HURON-CLINTON METROPOLITAN AUTHORITY
FLATROCK DAM 2008 REPAIRS

AS-BUILT ("A.B.") DRAWING NOTES	JRR	By	Appd.	01.10
Revision				MM.DD.YY
BID SET				05.08
OWNER REVIEW				03.08
QA/QC (95%)				02.08
ROAD COMMISSION SUBMITTAL (WCOPS)				01.08
REVISIONS PER MDO				12.13.07
PERMITS (90% SET)				10.31.07
60% REVIEW				07.07.10
Issued		By	Appd.	MM.DD.YY

SOIL EROSION CONTROL AND MISC. DETAILS

**RIGHT SIDE, LOCK
DEMOLITION PLAN**

PAVEMENT REPAIR AT FENCE POST DETAIL

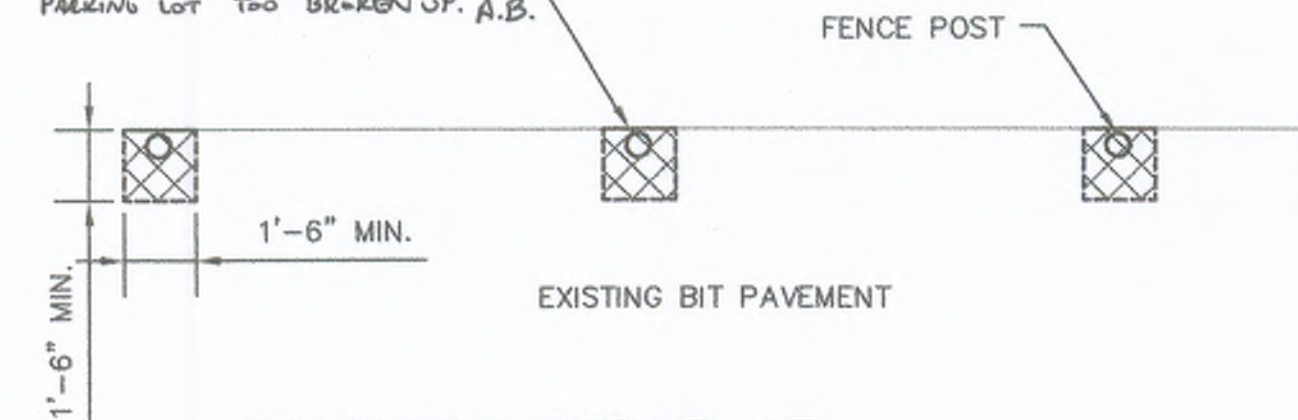
1. SAWCUT AND REMOVE BITUMINOUS PAVEMENT.
 2. REMOVE OLD FENCE POSTS AND REPLACE WITH NEW POSTS.
 3. CAP WITH 6" MIN. CONCRETE.
 4. SEAL EDGES AND OVERCUTS.
- SEE STANTEC INF. REPORT A.B.
Not Done By Contractor. Paving lot Too Broken Up. A.B.

FISH LADDER SILT BARRIER DETAIL

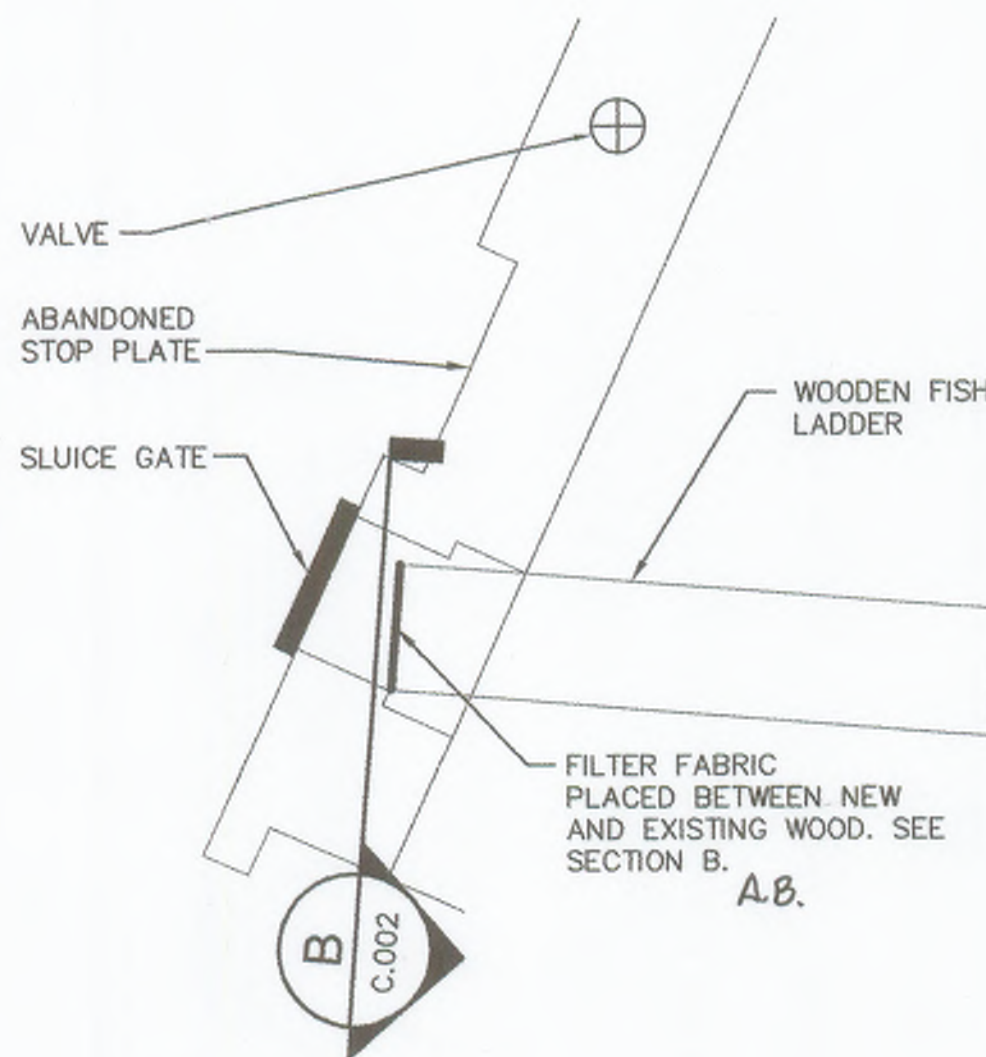
NOTCH INTO EXISTING GRADE AS NECESSARY. A.B.

FILL LOWER AREAS WITH HEAVY RIP RAP AS NEEDED. 14" MAX. DEPTH. A.B.

TEMPORARY RIP RAP
10" THICK OF 2x3-1x3
CRUSHED STONE. A.B.

TYPE II OR TYPE III TURBIDITY CURTAIN

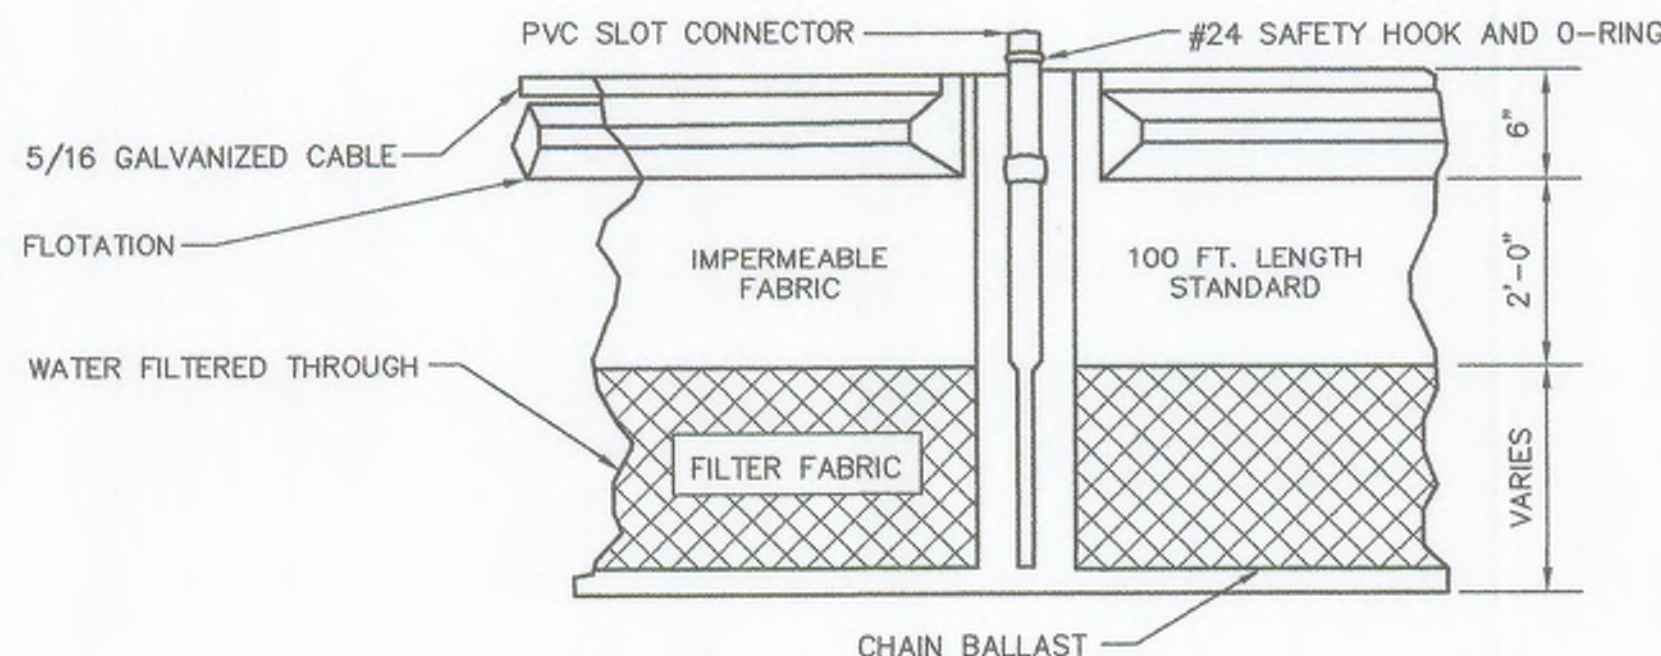
(SEE SUBMITTAL) A.B.

LOCK SITE PLAN

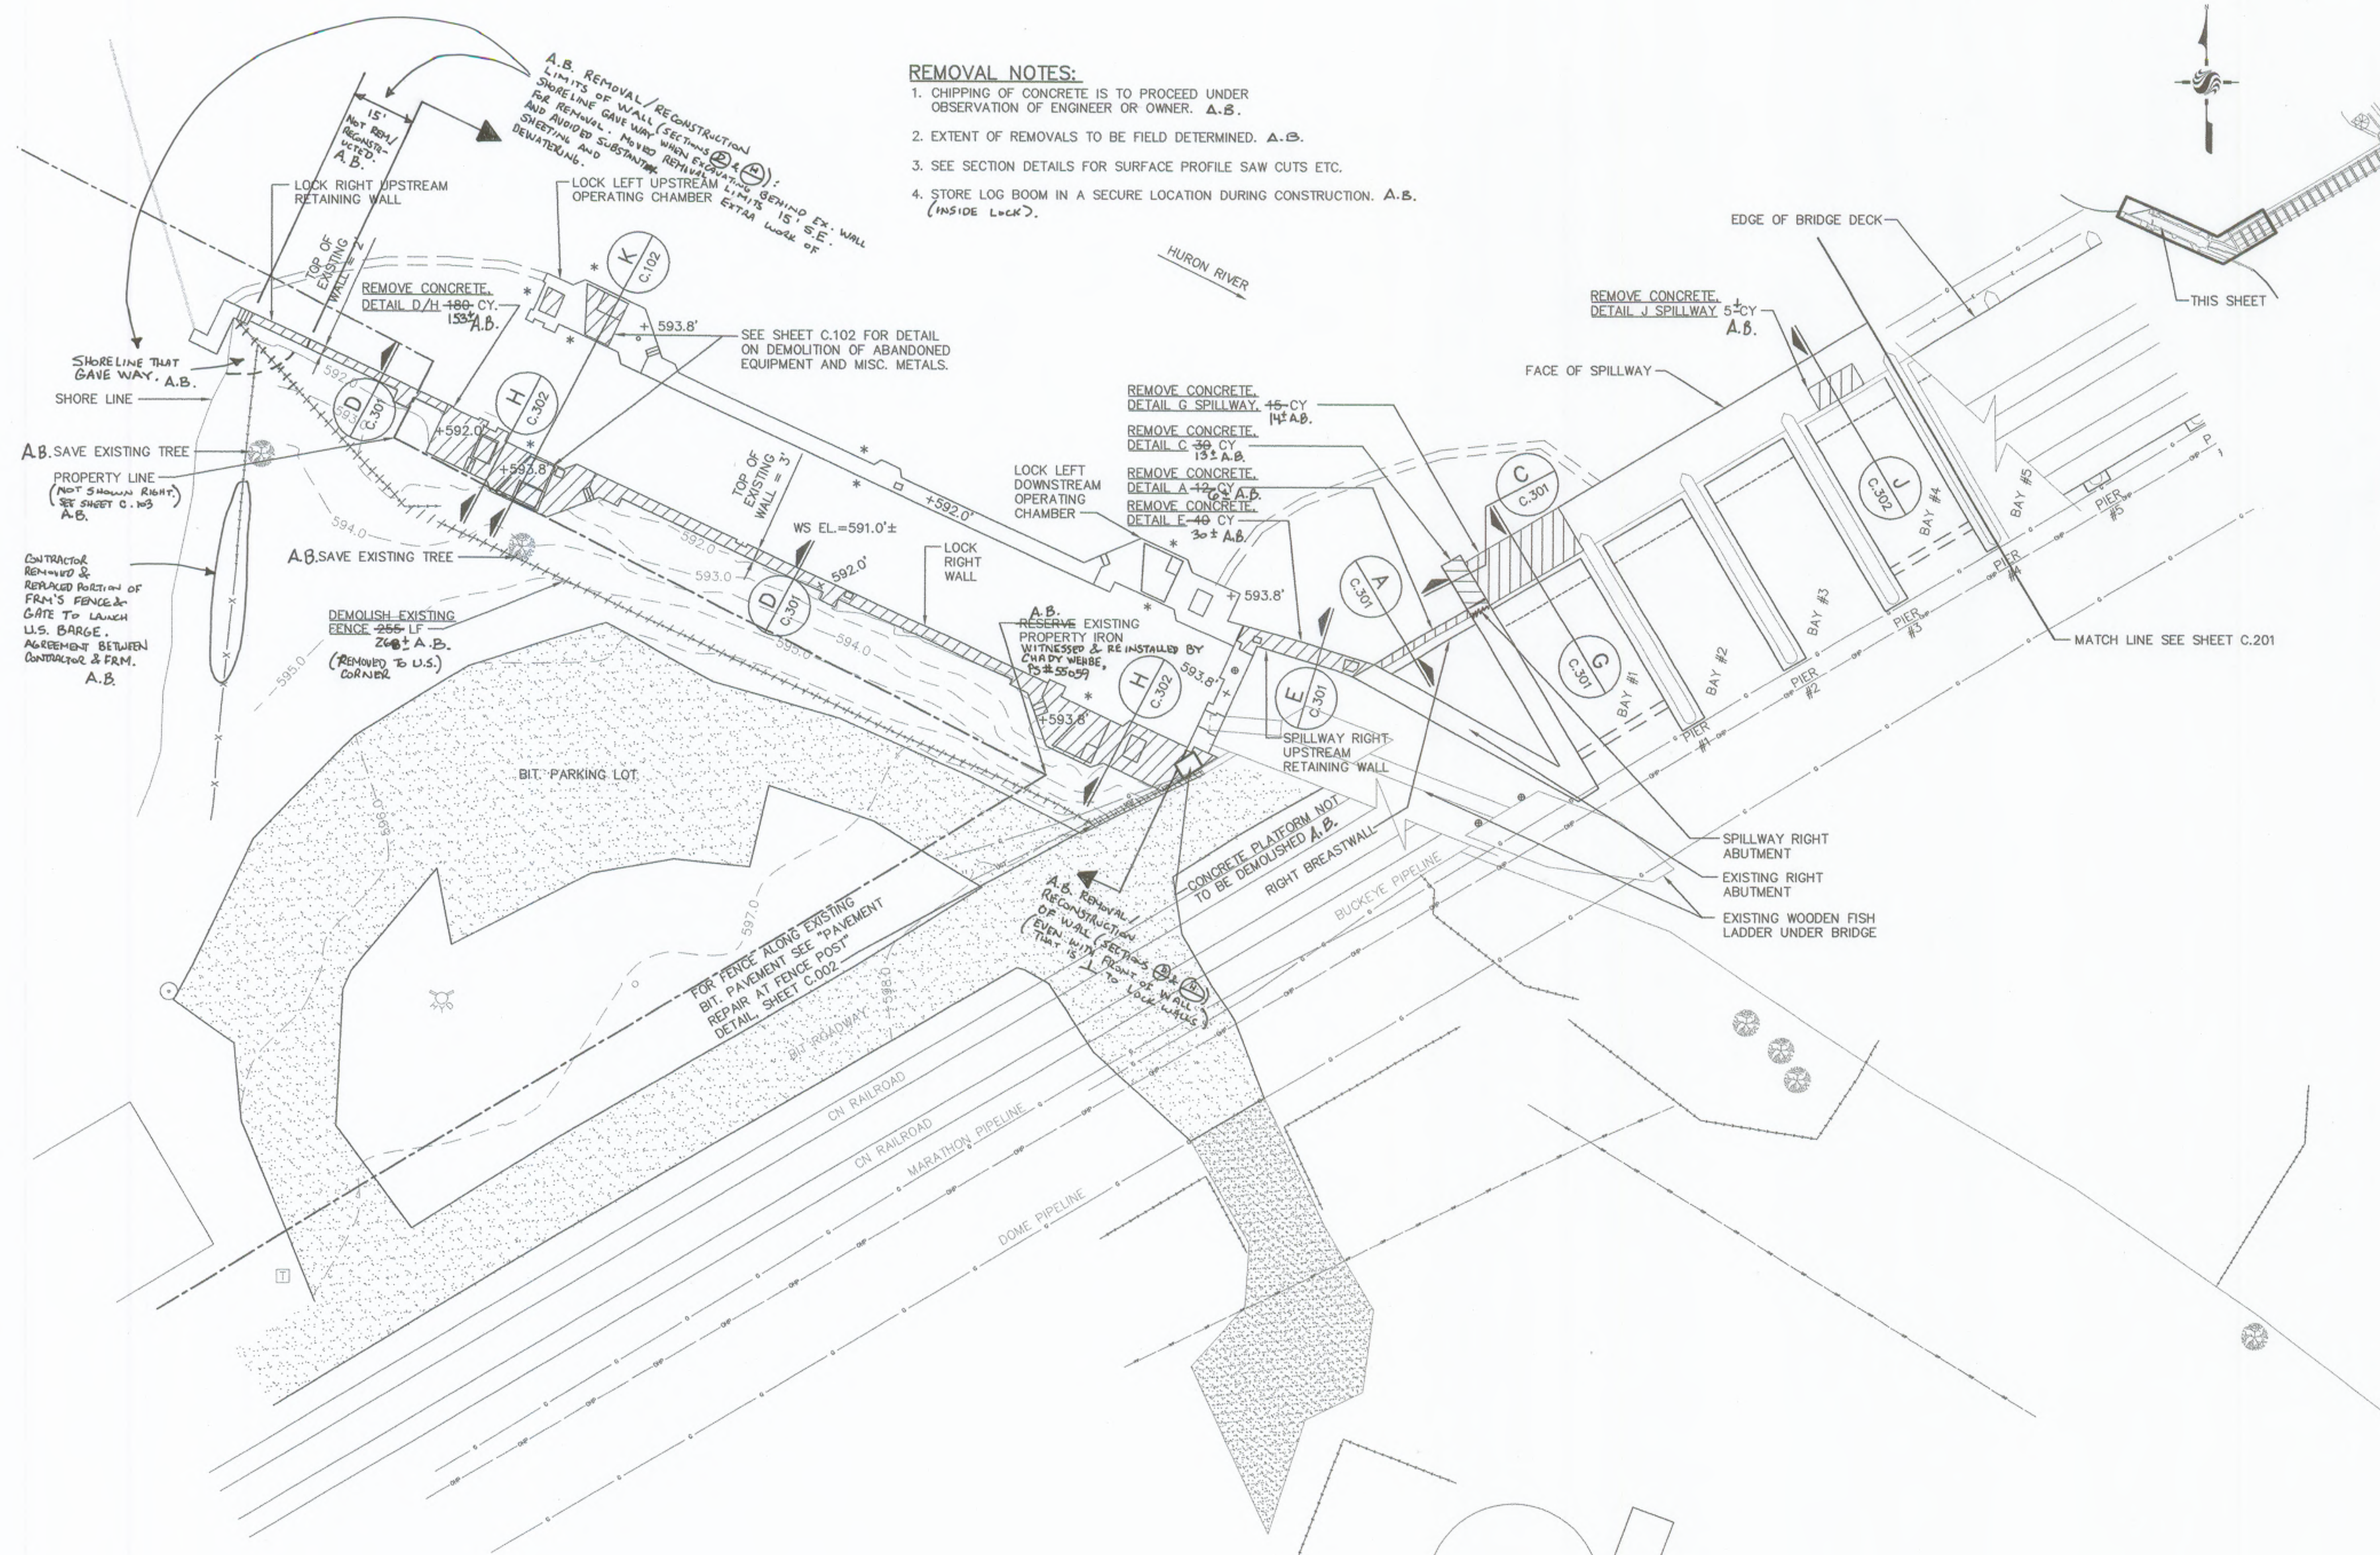
1. CHIPPING OF CONCRETE IS TO PROCEED UNDER OBSERVATION OF ENGINEER OR OWNER. **A.B.**
2. EXTENT OF REMOVALS TO BE FIELD DETERMINED. **A.B.**
3. SEE SECTION DETAILS FOR SURFACE PROFILE SAW CUTS ETC.
4. STORE LOG BOOM IN A SECURE LOCATION DURING CONSTRUCTION. **A.B.** (INSIDE LOCK).

* INSPECT FOR UNDERWATER OPENINGS. **A.B.** - SEE DIVER REPORTS (2 EACH)
08.25.08 & 12.04.08/10.22.08
